13 April 2022

Dear HPC Members:

Following OGNED's meetings before the Historic Preservation Commission (HPC) on 6 & 27 April 2021, three members—Deborah Osepchuk, Lucinda Heinlein, and Jeffery Rudell—were asked by Bernie Haney, to meet and offer feedback to the development team on ways their application (the Plan) could be brought into conformity with the Architectural Design Guidelines (Guidelines). These meetings were similar to the informal weekly Tech Review meetings available to all applicants to the HPC.

Illustration B.11. — East elevation of proposed pediment-topped entry to courtyard corridor (Sheet A-5).

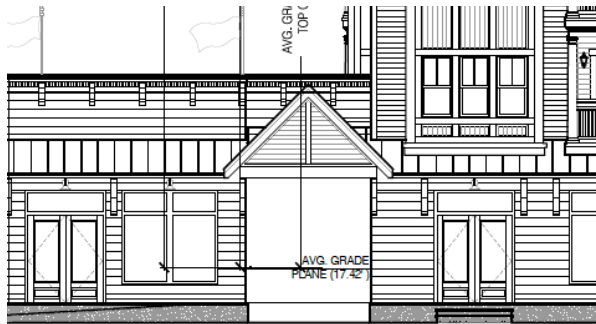
B.11. — Courtyard Corridor: At Tech’s request, OGNED agreed to reconsider the access corridor that leads from the boardwalk to the interior courtyard, to better highlight the access point and make it look more like a feature of the Retail frontage and less like an alley. At present, the pedimented entry has little relationship to the rest of the Retail area or the boardwalk itself. Tech asked OGNED to consider ways to extend that entrance forward (as a pergola or other structure extending toward the boardwalk) to better invite pedestrians into the space. The Plan presented did not activate courtyard access in any way, provided no shade, and seemed “uninviting.” No change to this area is reflected in the current Plan.

B.12. — Courtyard Corridor: Is the entrance to the courtyard at grade (at boardwalk level) or raised to the level of the sidewalk that runs in front of the Retail? If at grade, what accommodations are made to access the courtyard entrance from the raised sidewalk? Also, will the handicap accessible ramp necessitate closing off the sidewalk with a railing where it meets the corridor entrance? (See Illustration B.11., above.)

Illustration C.5.a. — North roof elevation of the Hotel (Sheet A-12).

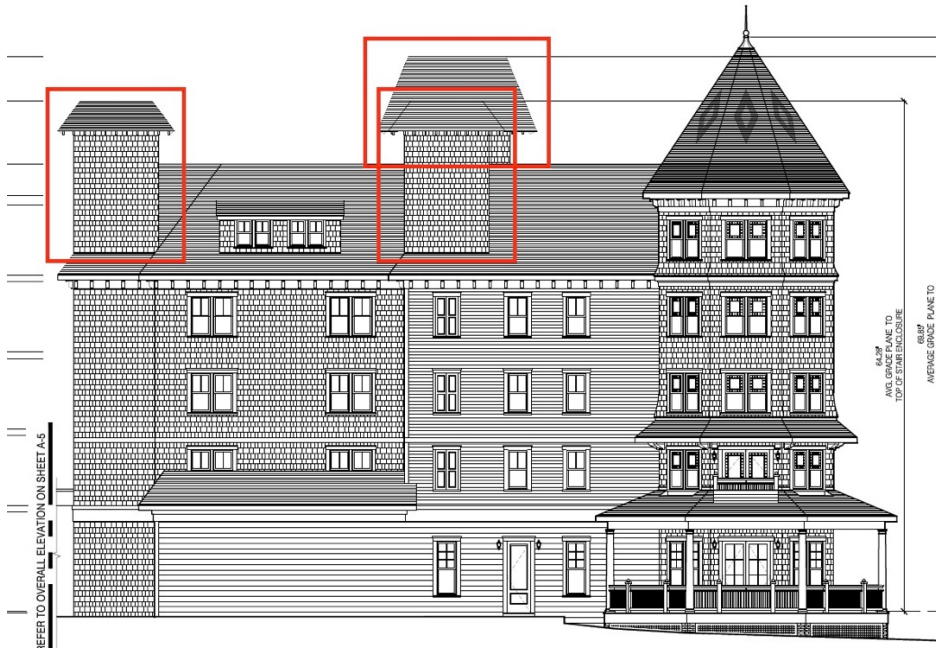
C.5. — **Hotel: Roof Projections.** Two staircase towers also serve the non-conforming roof decks and present similar design non-conformities as a result.

Illustration C.9. — Hotel dormers, south elevation, showing proposed paneled gable ornamentation (Sheet A-11).

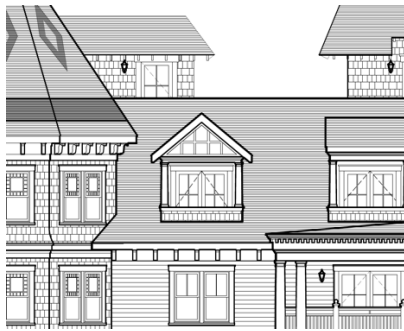
C.9. — Hotel: Dormers. The inclusion of paneling in the dormer gables at the south and east is historically inappropriate. Examples exist of doweled screens and orthogonal lattice in gables, but paneling of this sort is not appropriate.

Illustration C.10.a. — South elevation of Hotel dormers showing proposed mini-Tuscan columns (Sheet A-11).

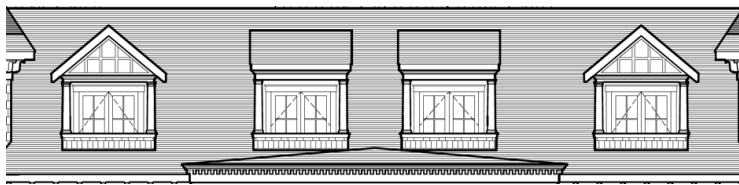
C.10. — Hotel: Dormers. Use of Tuscan columns on roof dormers on the south and east elevations are inappropriate. Properly scaled corbels, similar to those used at the tower balconies below the pent, are more appropriate and would help unify the design through repetition.

Illustration D.3.a. — South elevation of Hotel dormers showing proposed double doors (Sheet A-11).

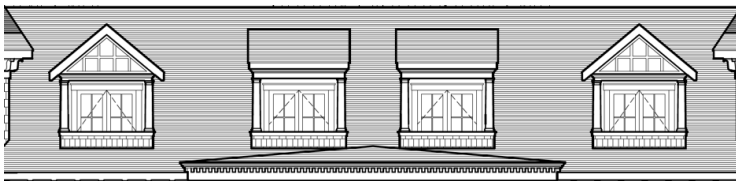
D.3. — **Hotel:** Double doors proposed for dormers are over-scaled and leave no room for lighting fixtures (which are not shown). Single doors would be more proportional in dormers of this size.

Illustration G.4.a. — Second floor plan of Condominium Building One showing hybrid inset balconies at all four elevations (Sheet A-2).

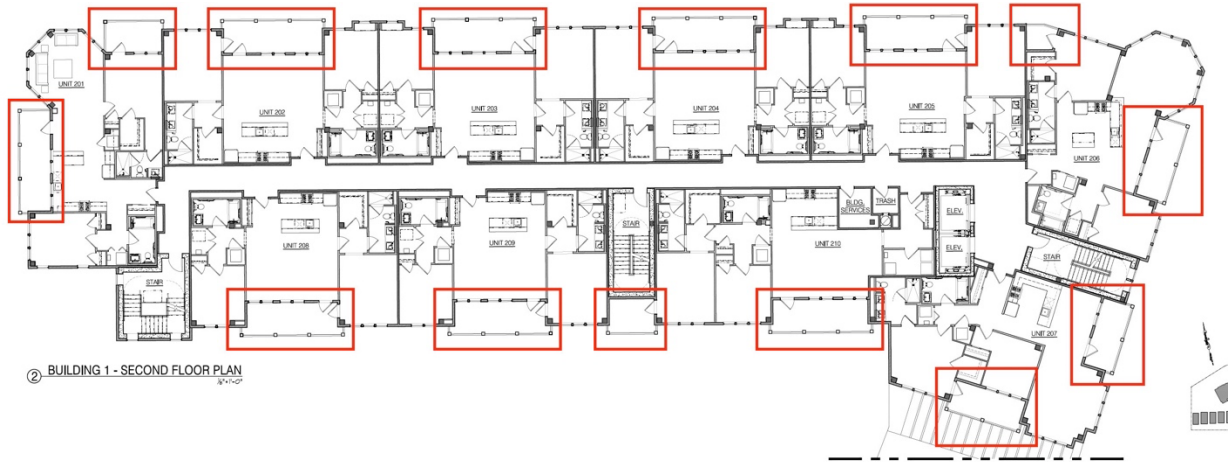
G.2. — **Condominiums:** Inset balconies are counter-historical, especially when used in place of porches. Porches usually project from a building face, provide a human scale to buildings by visually stepping down in size from the body of a building, and add visual interest to buildings by relieving visual mass. Porches enhance a sense of community and promote interaction between a building and its surrounding streetscape. Inset balconies are carved into buildings, are often cut off from the surrounding streetscape, and do not promote interaction. OGNED offers neither strict porches nor strict inset balconies, but rather hybrids where the majority of the open-air spaces are inset into the body of the buildings with minimal extensions. These limit the change in plane of the buildings, contribute to the visual mass of each structure, and inhibit the sense of community that is vital to Ocean Grove. Tech considers these hybrid balconies non-historic and non-conforming.

Illustrations G.5.a. and G.5.b. — Detail of northeast corner of Condominium Building One showing windowless mini-balconies above the north building access door (Sheet A-6). These balconies are circle in the second-floor plan, at right (Sheet A-2).

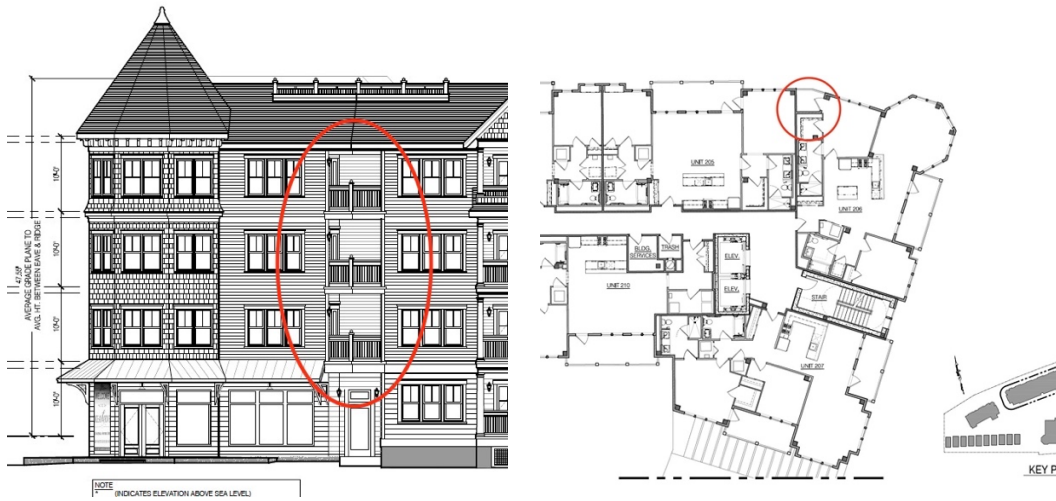
G.5. — **Condominiums:** At the north elevation, just west of the Building One tower, above the north access door, are a row of inset-balconies. These balconies occur at the point where the building jogs southwest along Wesley Lake. These balconies are five-sided, due to a bend in their railings, have no windows, single doors, and no lighting. They are non-historic in character, awkward in size and placement, and differ in every way from any other balcony in the project. Tech recommends they be reconsidered or eliminated.

Illustration H.6. — Plan showing proposed Condominium Building One roof path and roof deck (Sheet A-4).

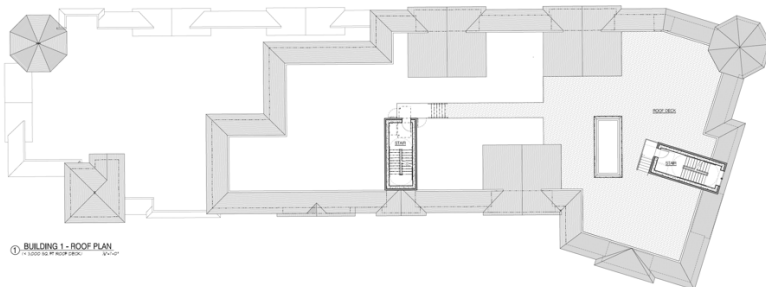
H.8. — **Condominiums:** Are railings proposed for the rooftop pathway and roof deck of Condominium Building One? Please provide cat/cut for review.

Illustration N.1.a. — Proposed coverage of Hotel Roof deck (emphasis added) (Sheet A-10).

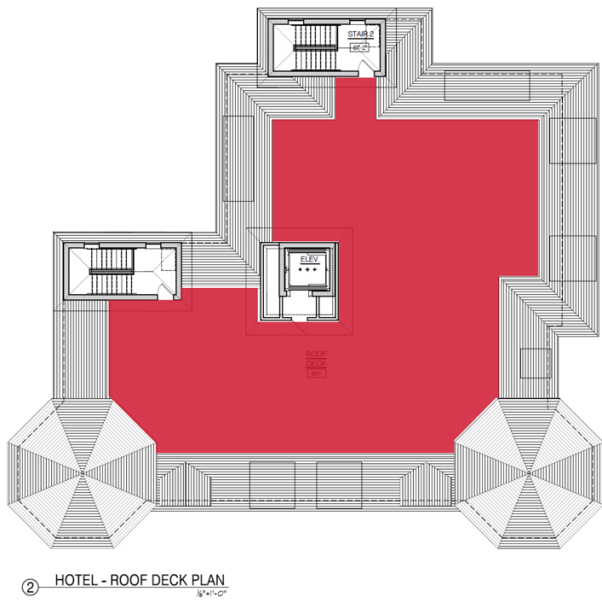
N.1. — **Roof Decks.** The Hotel & Condominium Building One each have large-scale, public roof decks. Condominium Building Two has three private roof decks. Roof decks are non-conforming with the Guidelines. The roof decks proposed are visible in so far as railings and

balusters along the parapet provide “viewing platforms” (some beneath the proposed faux-gables). These breaks in the parapet reveal the presence of the roof decks. There is a reasonable expectation that appurtenances related to roof decks (umbrellas, tents, pergolas, rooftop plantings, lighting, etc.) will further reveal the presence of these roof decks atop these buildings. (See, Guidelines, page 27, Section N, “Roof top construction featuring sun decks, swimming pools, and hot tubs are not in keeping with the designs of the Victorian Era nor other historic styles of architecture within the Ocean Grove Historic District. Therefore, such features will be viewed contrary to the “Spirit” of the architectural setting. Introduction of any such feature must fully demonstrate that such a feature would be designed so as not to be visible to public view...”)
